OR TAMBO LEGACY PROJECT -DAC HERITAGE PROGRAMME ARCHITECT'S IMPACT REPORT ON STRUCTURAL REMEDIES RESTORATION OF THE OR TAMBO DWELLING 6 JUNE 2014

By IDC Architects

For: Independent Development Trust

Images 001 & 002: Indicating damages to brickwork, roofing and gumpoles.

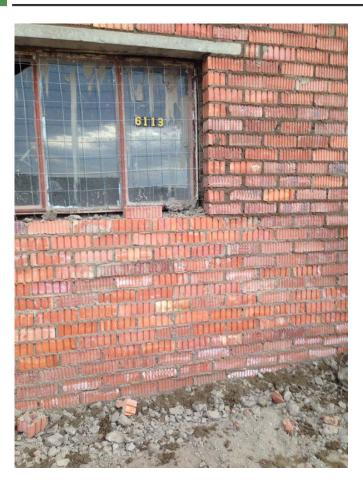
The original external walls of the dwelling which had cracks and were leaning away from the vertical had been covered by a new skin of brick work with a concrete filled cavity as support. The new external wall skin had been build to near perfect square.

The impact with this intervention is visual and the newly built walls are contrary in form to the uneven vernacular walls wich are found in the original walls of the buildings. The position and scale of the ventilation openings in the external walls have been maintained and therefore not affected. It is recommended that the plastering trade is redone to achieve an uneven but smooth texture to achieve the aesthetic integrity of the original dwelling. The overall elevations in length have been increased by 380mm as a result of the new external skin and cavity.
